EQUIPMENT SERIES: KWM

BULLETIN NO. 2

EQUIPMENT TYPE: KWM-2, KWM-2A

SUBJECT: ADD VOX RELAY TIME CONSTANT CONTROL.

Figure 1. KWM-2/2A VOX Circuit Schematic Changes

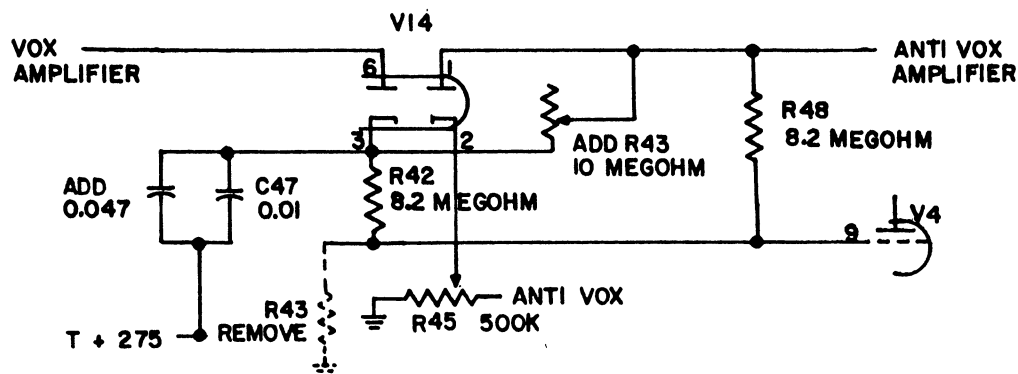
See figure 1 for circuit changes.

1. Remove the feet from cabinet.
2. Lift lid and remove the two unpainted screws from the top rim of the front panel.
3. Slide unit out of cabinet.
4. Remove and discard the 10-megohm resistor R43 located between V4, pin 9 and ground.

5. Add 0.047-uf capacitor (931-0295-00) in parallel with 0.01-uf disc capacitor located between pins 1 and 3 of E50. E50 is a mounting turret post located between XV4 and XV14 tube sockets. Sleeve leads of new capacitors with insulation (152-1613-00). See figure 2.

Figure 3. Installation of VOX Time Constant Control and Bracket

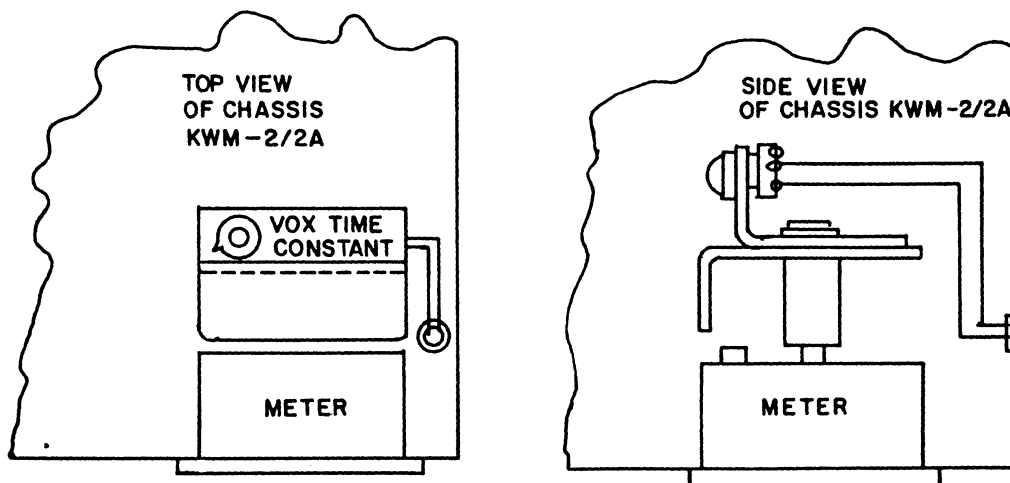
7. With transceiver in upright position, remove the two nuts holding the shield to the back of the meter.
8. Mount VOX TIME CONSTANT control bracket (546-7971-00) on the meter shield using hardware removed in step 7. See figure 3.

9. Solder either one of the 18-inch wires to the center terminal of the control.
10. Solder the other wire to the counterclockwise terminal (as viewed from the shaft end) of the control. Refer to figure 3.
11. Mount VOX TIME CONSTANT control (376-7206-00) in the new bracket, using hardware and knob included in kit.
12. Reassemble unit.

KWM-2 After Modification, Schematic Change

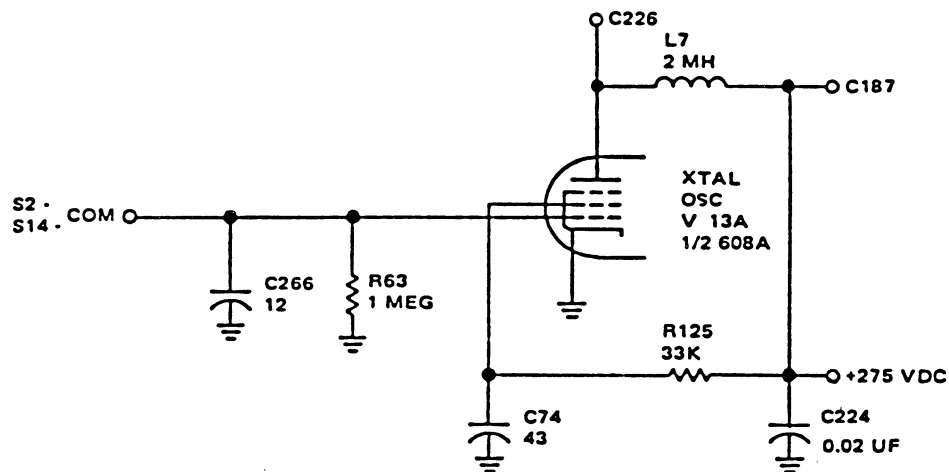
- c. Remove and discard 27-pF capacitor C266, if present, from XV13A pin 2 to the center shield of V13 (ground), and install at this location a 12.0-pF capacitor (912-2757-000), KWM-2 only.
- d. Remove and discard 47-k Ω resistor R125 from XV13A pin 2 to vector terminal board E100, and replace with 33-k Ω resistor (745-1415-000).
- e. Remove and discard 47-pF capacitor C74 from XV13A pin 3 to ground, and replace with 43.0-pF capacitor (912-2789-000).
- f. Inspect unit for damage incurred during modification, dress wires and cables, and remove debris.
- g. Reassemble unit by reversing step a.
- h. Check transceiver for proper operation.
- i. Mark information chart (280-3778-010) SB 3R. Apply chart to convenient location on unit if one is not present.

Figure 1. Location of Components Affected by this Modification.

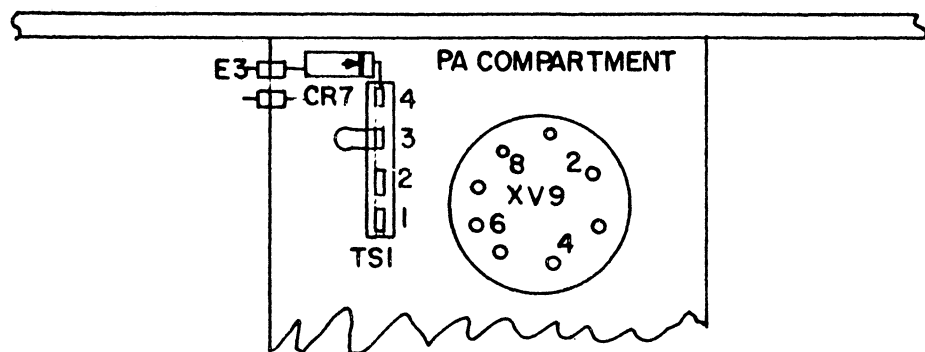
1. Remove cover of unit.
2. Connect a voltmeter from terminal 3 of tube socket XV9 to chassis ground. Set meter on 300-volt scale.
3. With power applied, turn EMISSION switch knob to LOCK KEY. Meter should read approximately 280 volts.
4. Turn EMISSION switch knob to USB so that unit is in receive function. Immediately upon switching, turn meter to 30-volt scale. If voltage is indicated and dies off slowly, there is screen grid emission on one or both 6146 tubes.
5. If screen grid emission is present, remove bus wire that is connected from terminal E3 (feedthrough terminal located near rear apron in PA grid box) to terminal 4 of terminal strip TS1. Install in its place a 1N1490 diode (353-1659-00) with anode connected to E3. Refer to figures 1 and 2.

KWM-2/2A Relay Mounting Plate Drilling Instructions
Figure 2

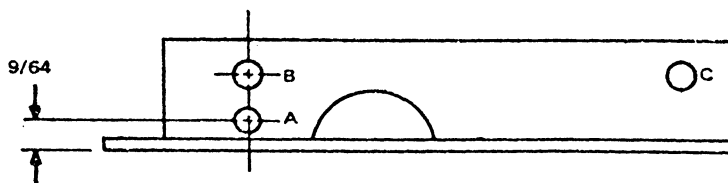
NOTE: A number of relay mounting brackets already have the hole A drilled to proper size and location. Check bracket (768-5928-001) with figure 2, and if hole A exists, disregard step 13.

13. Drill hole in relay mounting bracket (768-5928-001) according to the instructions on figure 2.
14. Position relay bracket in chassis with hole B centered on the sheet metal screw located approximately 1 1/4 inches from PA cage, with bracket parallel to the PA. Holding in this position, center punch through bracket holes A and C.

- 18. Place the relay mounting bracket in position over the two new holes (step 15) with the socket terminals toward operator.
 - 19. Place solder lug (304-0317-000) over relay bracket hole C, position toward front of unit, and secure bracket to chassis with screws (330-0731-000) through holes A and C (figure 2).

Part A, Schematic Change

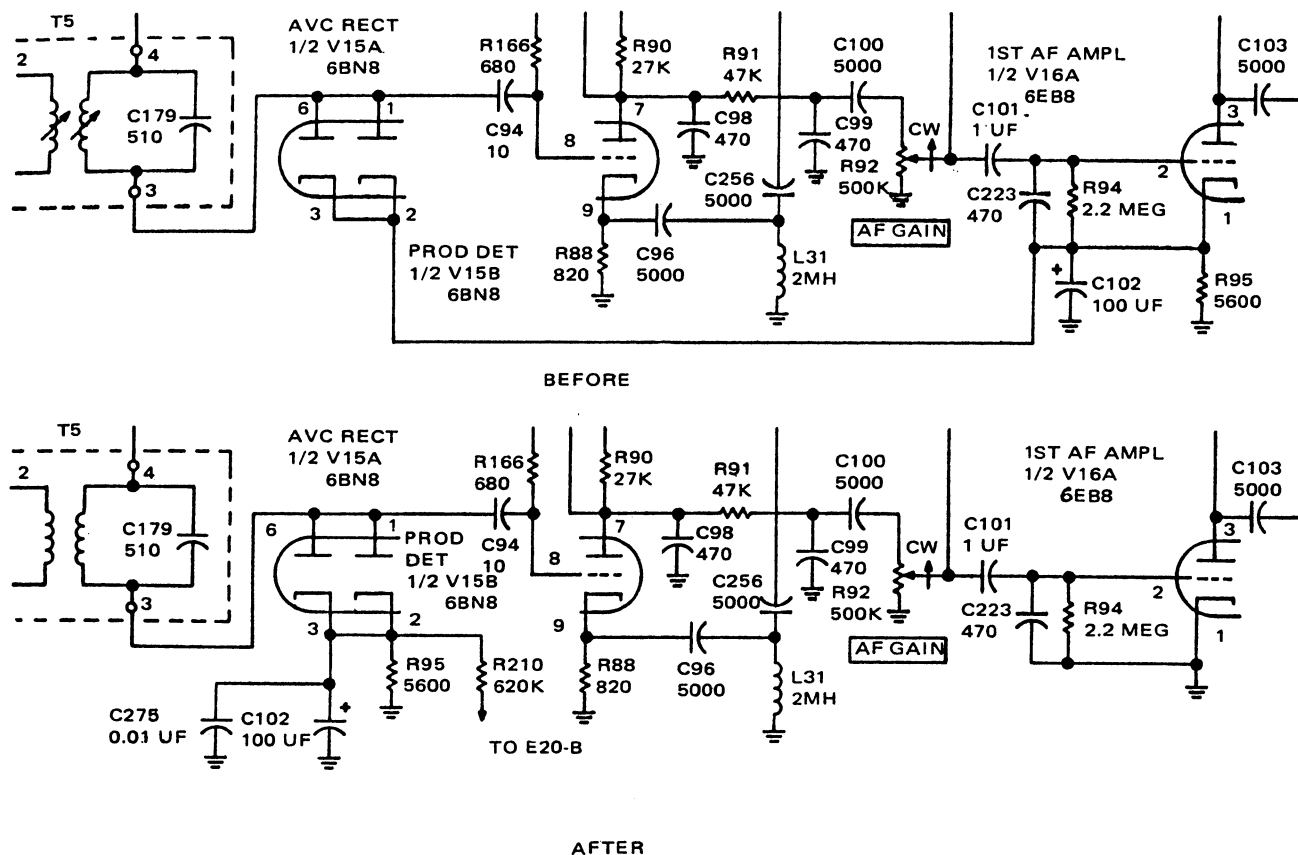
- (a) Place transceiver upside down on workbench with knobs to the right. Remove and save the screws used to attach the two nylon cable buttons to the strengthening rail. Remove and save the screw attaching the rear of the strengthening rail to the chassis. Remove and save the screw attaching the front of the strengthening rail to the chassis, taking care not to lose the nut, lockwasher, and flat washer underneath the rail. Remove the rail, saving any protective material located between the cable and the rail.
- (b) Remove all components attached to E30-C, as follows:
- 1) 4700-ohm 1/4-W resistor, R82, connected from T5 terminal 4 to E30-C.
 - 2) 0.01 μ F disc ceramic capacitor, C92, connected from E30-I to E30-C.
 - 3) 3.3-m Ω 1/4-W resistor, R83, connected from E30-C to E30-J.
 - 4) 0.05- μ F capacitor, C93, connected from E30-C to E30-J.

- (c) Remove 0.001- μ F disc ceramic capacitor, C256, connected from TS8-1 to ground ring on power connector.
- (d) Connect R83, 1.5-M Ω 1/2-W resistor (745-1485-00), from E30-C to E30-J.
- (e) Connect C93, 0.47- μ F capacitor (913-3804-00) from E30-C to E30-J.

- (f) Connect R82, 4700-ohm 1/2-W resistor (745-1380-00), from T5 terminal 4 to TS8-1. Use sleeving on leads and route this resistor around E30.
- (g) Connect R180, 680-k Ω 1/2-W resistor (745-1471-00), from TS8-1 to E30-C.
- (h) Connect C265, 0.01- μ F disc ceramic capacitor (913-3013-00), from TS8-1 to E30-C.
- (i) Connect C90, 0.01- μ F disc ceramic capacitor (913-3013-00), from TS8-1 to ground ring on power connector.
- (j) If no additional modifications are to be implemented, replace all hardware by reversing step (a).
- (k) Mark SB 8A on information chart (280-3778-010) and apply chart to convenient location on unit, or mark existing chart if one is present.

Part B Schematic Change

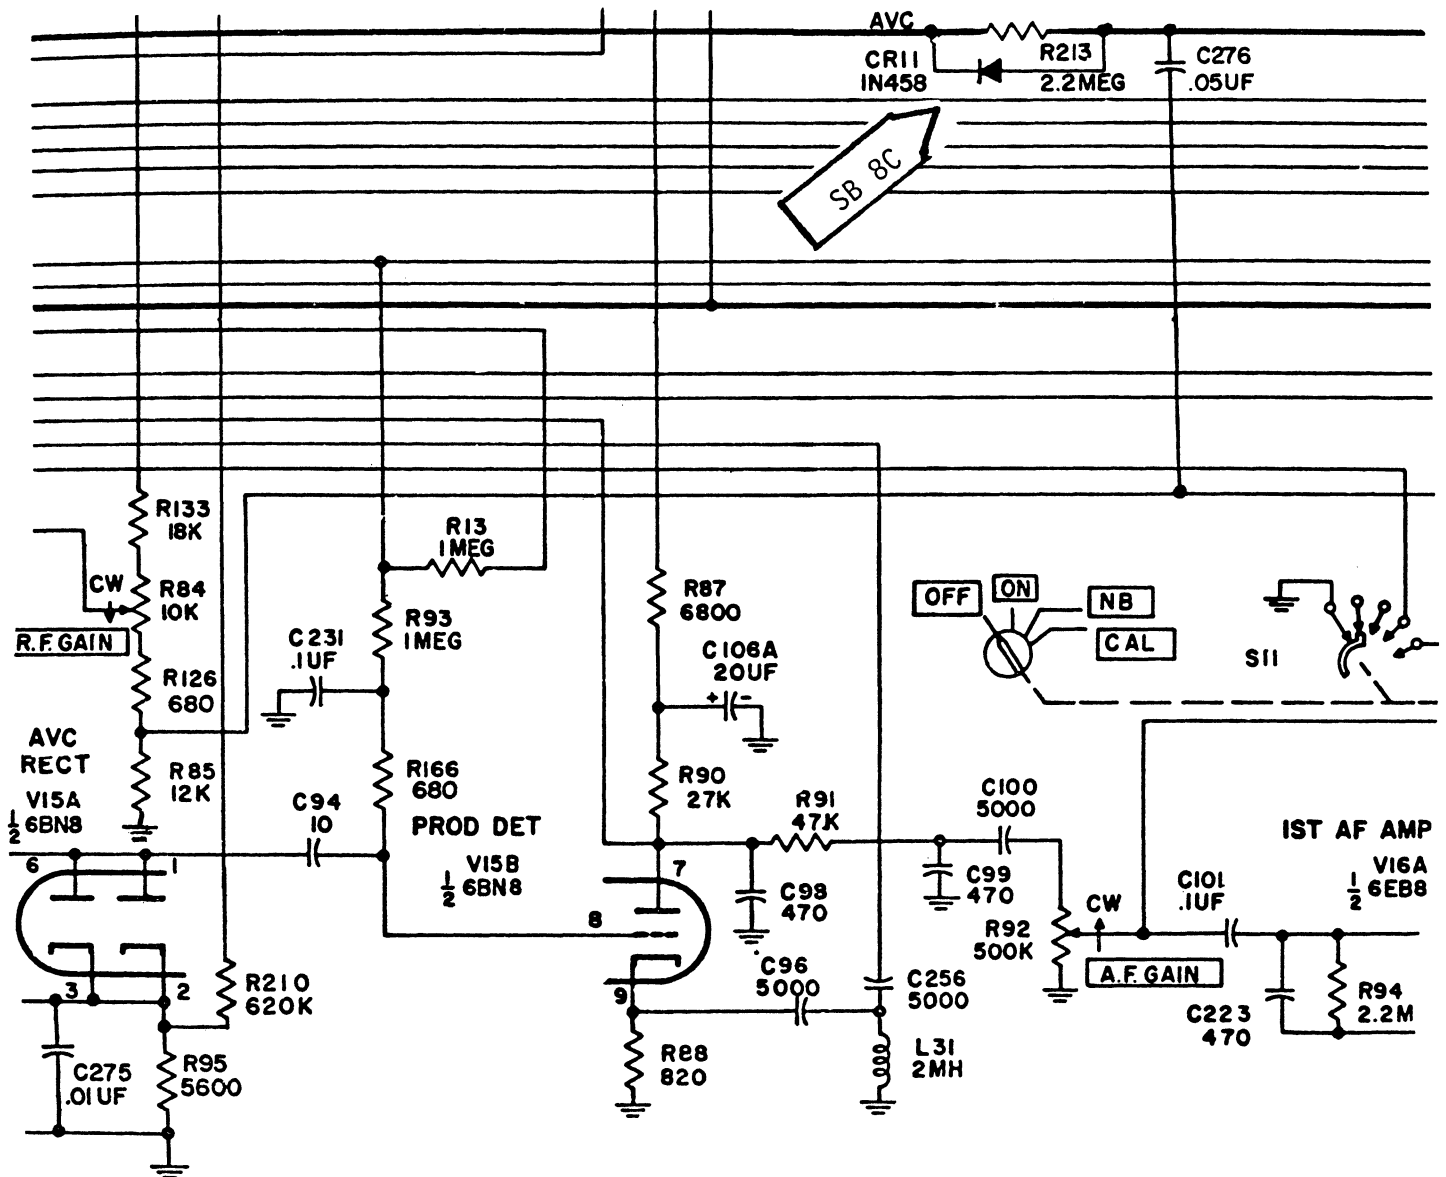
- Disconnect bus wire at tube socket XV15-2. Remove sleeving and route wire to center shield on XV16. Shorten wire as necessary, connect and solder.
- Add 620 k Ω resistor R210 (745-1469-000) from E20-B to XV15-2.
- Add 0.01 μ F capacitor C275 (913-3013-000) from XV15-3 to nearest ground.
- Mark information chart (280-3778-010) SB 8B. Apply chart to convenient location on unit if one is not present.

KWM-2 Amateur Transceiver, Additional
Crystal Board, Installation Drawing
Figure 1 (Sheet 1 of 3)

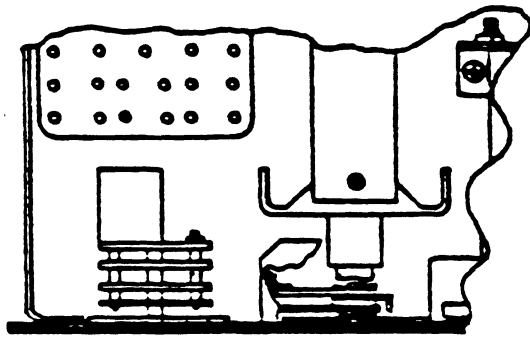
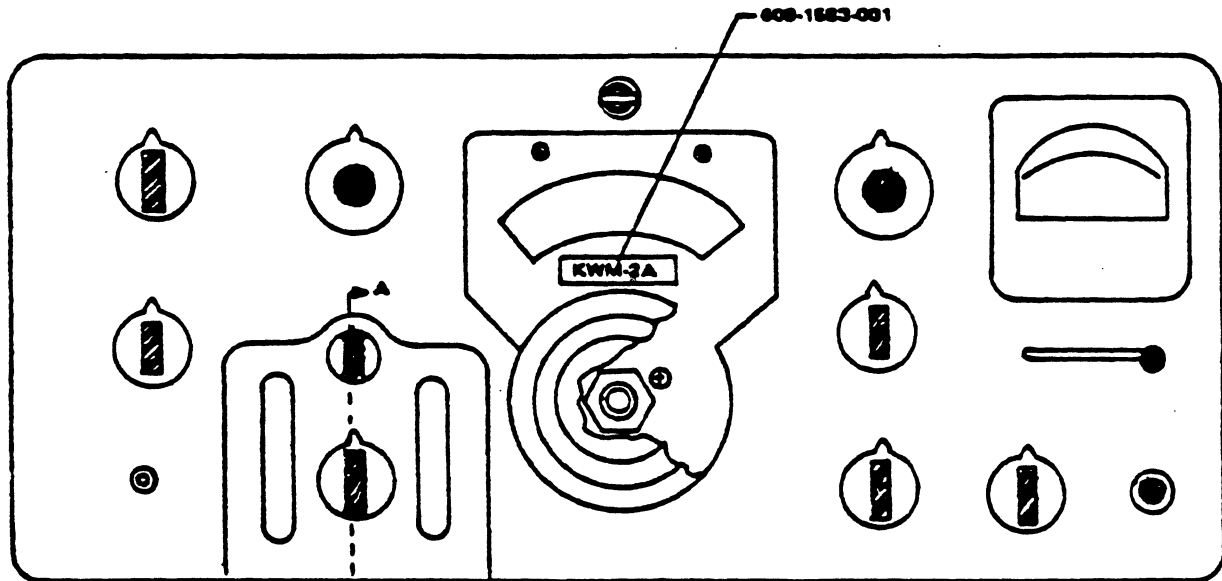
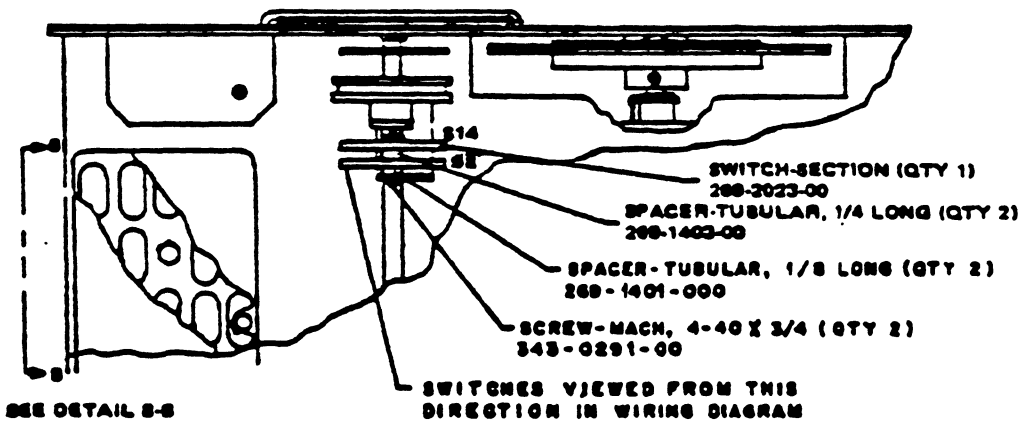
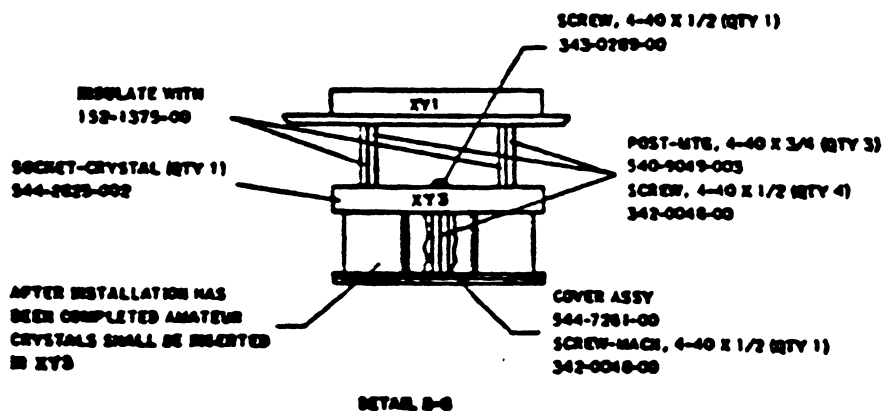
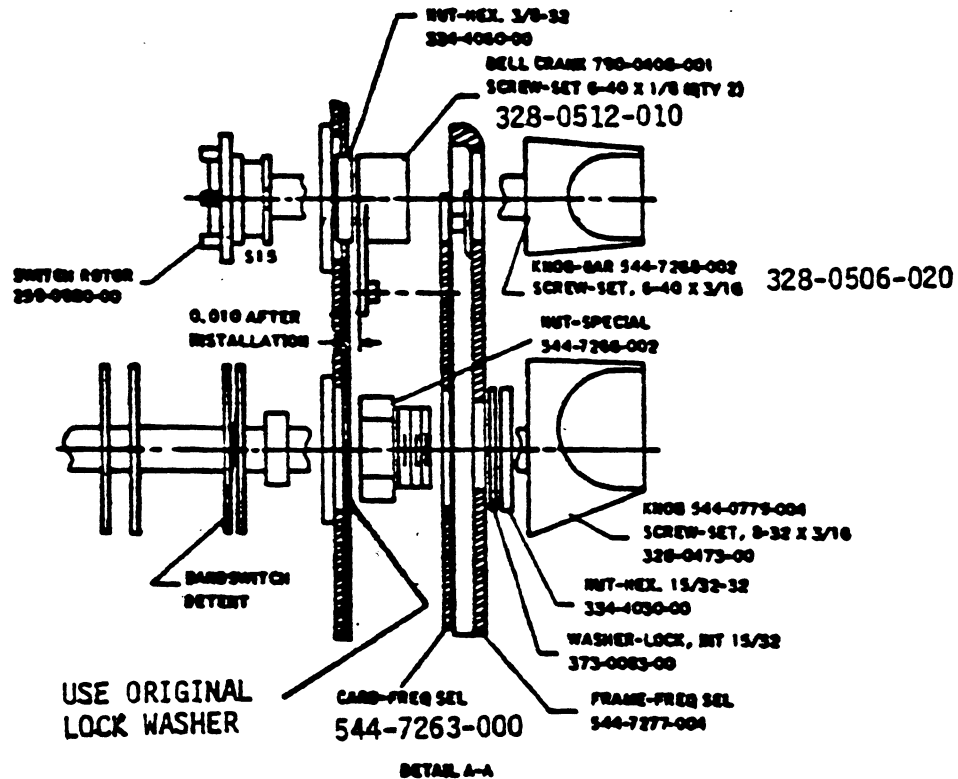
- h. Observe detail A-A in figure 1. Note the parts that make up the assembly and their relative positions, then install switch S15 and all other parts.

- i. Refer to the wiring diagram of figure 1. Install wires from S15 to S2 and S14. Then install coax from S15 to XV13. Wire socket XY3 and switch S14.

- j. Observe detail B-B in figure 1. Mount crystal socket XY3 using kit hardware specified in the drawing.
- k. Transfer the amateur band crystals from XY1 to their respective positions in XY3 (under the chassis).

V2 Socket, Bottom View
Figure 1

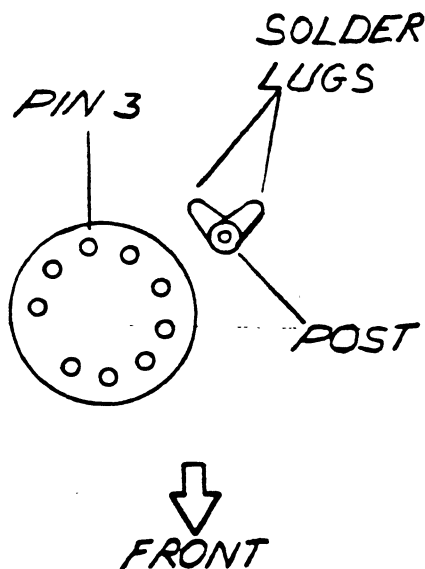
- c. Refer to figure 1 and perform the following:
1. Locate and disconnect the 0.1- μ F capacitor, C49, and the 100-k Ω resistor, R49, from pin V2-3 (leave other ends connected).
 2. Remove and discard hardware securing solder lugs (near V2) to chassis.
 3. Install new post (306-0977-000) on top of two solder lugs by V2, using new screw (343-0286-000).
 4. Connect one end of new 47-ohm resistor (745-1296-000), R215, to pin V2-3 and other end to new post.
 5. Connect R49 and C49 leads (disconnected in step c.1) to new post.
- d. Reassemble cabinet.
- e. Check transceiver for proper operation and verify that no audible tone exists in CW mode with the key open.
- f. Enter SB 10 on the information chart (280-3778-010); apply chart to convenient location on unit if one is not present.

Partial Schematic
Figure 2

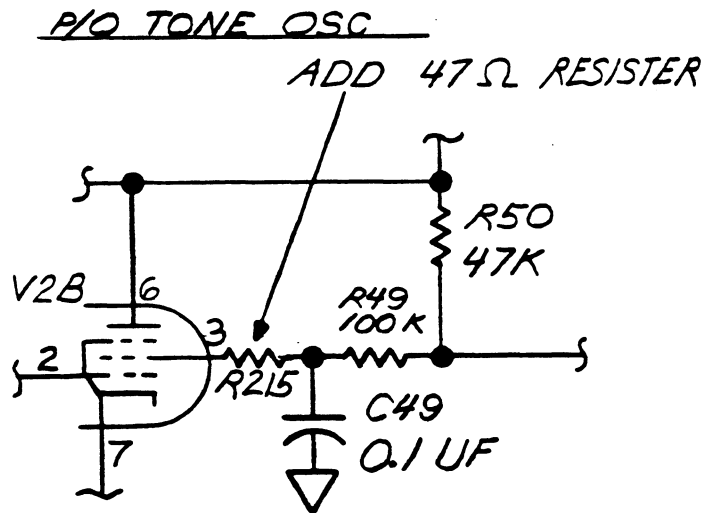
A 47-ohm resistor is added in series with the screen grid of tone oscillator V2B to act as a parasitic suppressor.
